Illinois Department of Transportation

SUBJECT: FAU 2406 (19th Ave. / Broadway Ave.)
Section 16-00131-00-BR (Melrose Park)
Cook County
Contract No. 61J48
Item 116
April 24, 2023 Letting
Addendum (A)

NOTICE TO PROSPECTIVE BIDDERS:

Attached is an addendum to the plans or proposal. This addendum involves revised and/or added material.

**LUMINAIRE, LED, ROADWAY, OUTPUT DESIGNATION G
POLE LAYOUT DIAGRAM**

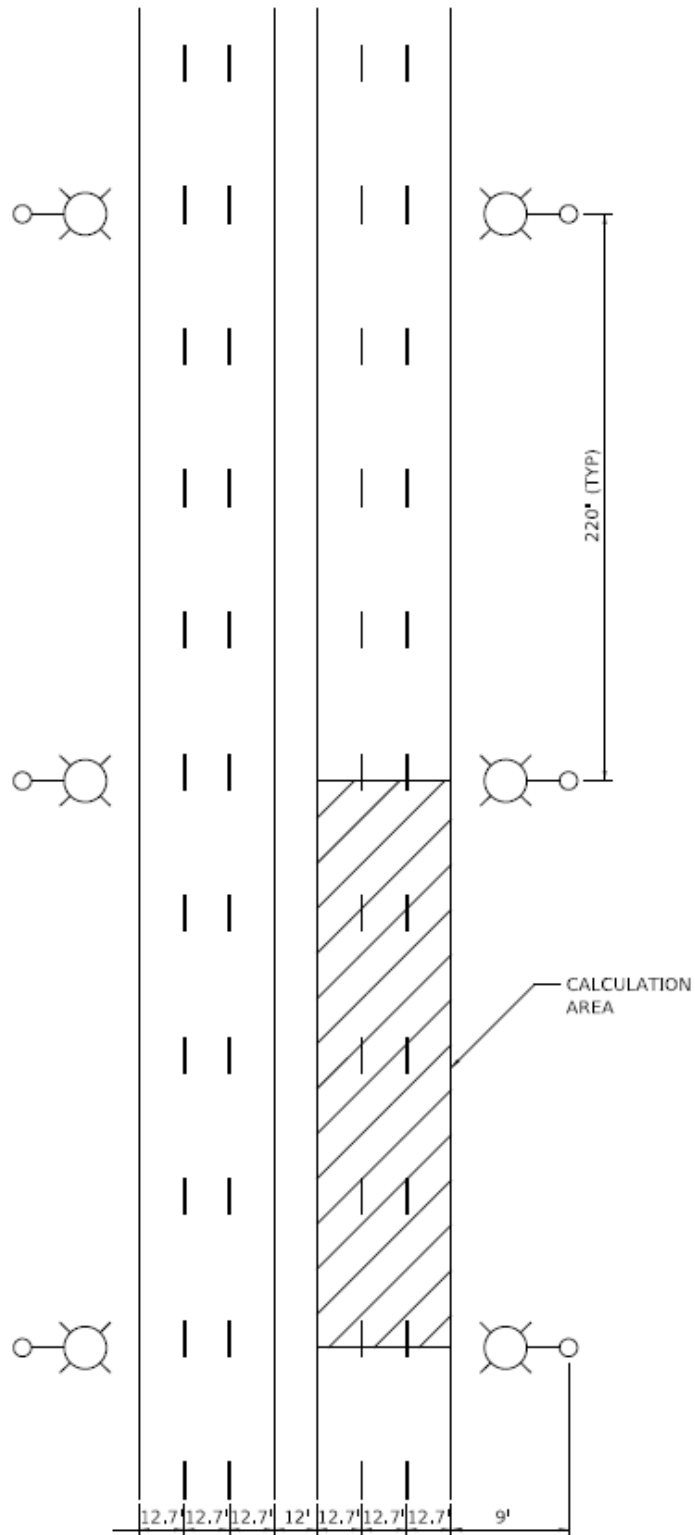
Revised 4/6/23
Addendum #1

**TEMPORAY LUMINAIRE LED, ROADWAY (OUTPUT DESIGNATION F)
POLE LAYOUT DIAGRAM**

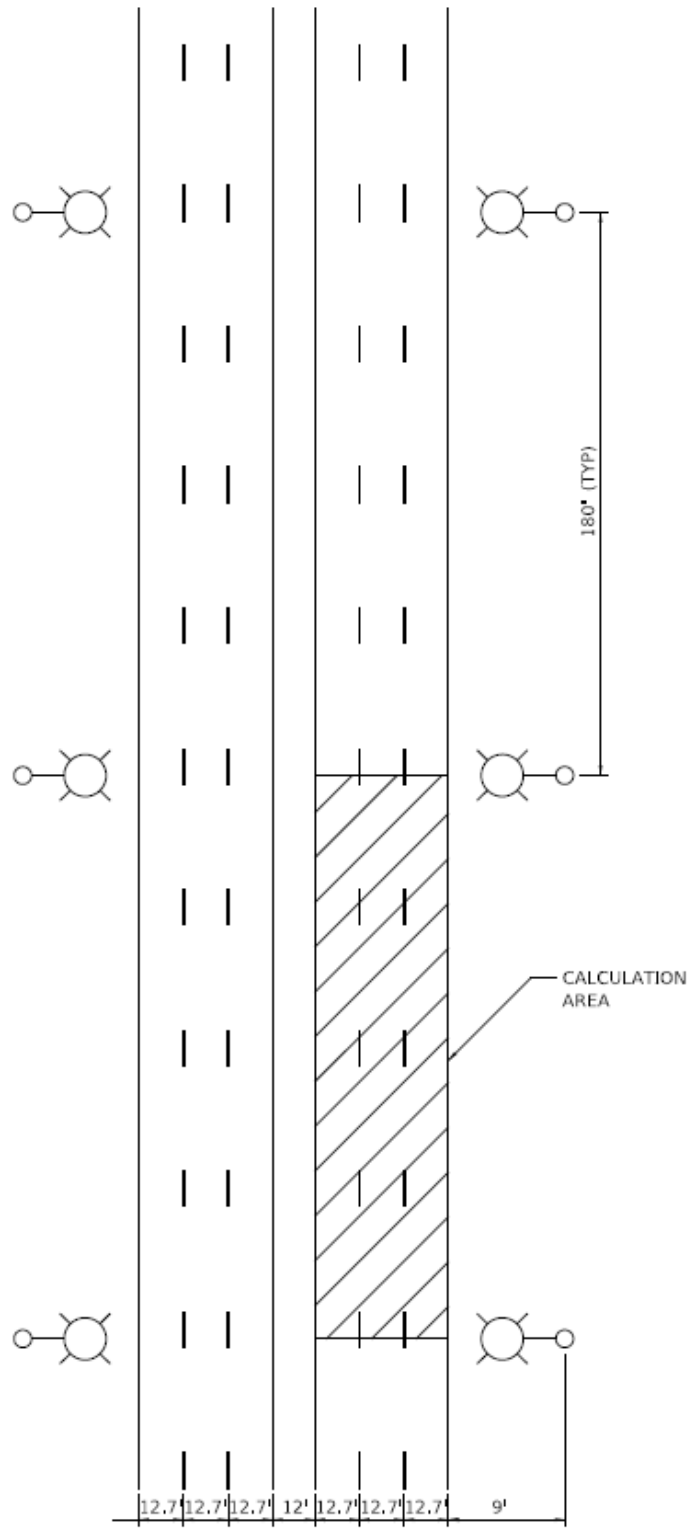
Revised 4/6/23
Addendum #1
